Access Compliance Report

Public Rights-of-Way

(Curb Ramps)

Intersection ID: 30550	Main Street: ARBORETUM SHOPPING CENTER DR	Side Street: PROVIDENCE RD	Location: NE
ADA ID: 3807ED5ED252	Ramp Type: PerpDiag	Initial Pass/Fail: Fail	Overall Compliance: No
Codes/Mitigation Info/Possible Solution		Field Measurements/Component Compliance	
Severity Score: 33.75

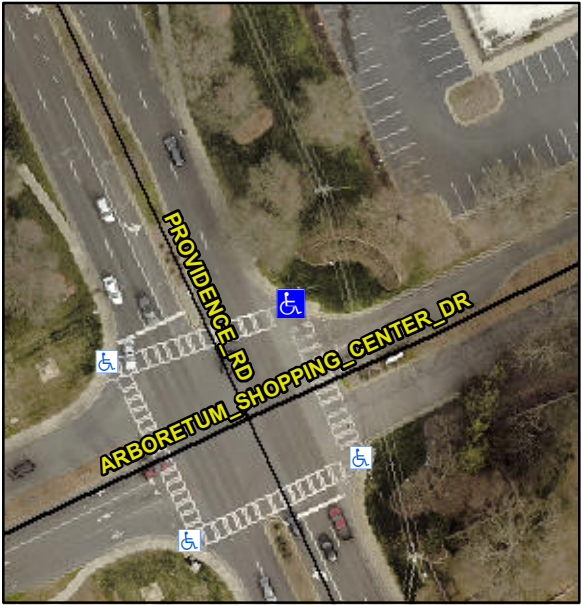
Possible Solutions:	Compliance	Description	Data	Compliance	Description	Data
	Remove & Replace Curb Ramp With Two New Directional Ramps or Equivalent.	N/A	Ramp Length (in)	62.0	No	Ramp Slope (%)	9.3
		No	Ramp Width (in)	38.0	No	Ramp XSlope (%)	5.1
		N/A	Flare Type LT	N/A	N/A	Flare Type RT	N/A
		N/A	Flare Slope LT (%)	N/A	N/A	Flare Slope RT (%)	N/A
		N/A	Flare Traversable LT?	N/A	N/A	Flare Traversable RT?	N/A
		N/A	Landing Length (in)	N/A	N/A	DWS Provided?	N/A
		N/A	Landing Width (in)	N/A	N/A	DWS Contrast?	N/A
		N/A	Landing Slope (%)	N/A	N/A	DWS Length (in)	N/A
		N/A	Landing X Slope (%)	N/A	N/A	DWS Full Width?	N/A
<p>Surveyor Notes:</p> <p>N/A</p> <p>PROW/ADA:</p> <p>R304.5.1, R304.2.2, R304.5.3</p>		N/A	Landing Curb? (Y/N)	N/A	N/A	DWS Offset (in)	N/A
		N/A	Shared Landing?	N/A			
		N/A	Gutter Ponding?	N/A	N/A	Gutter Slope (%)	N/A
		N/A	Gutter Lip Ht (in)	N/A	N/A	Gutter X Slope (%)	N/A
		N/A	Painted X Walk1?	Yes	N/A	Painted X Walk2?	Yes
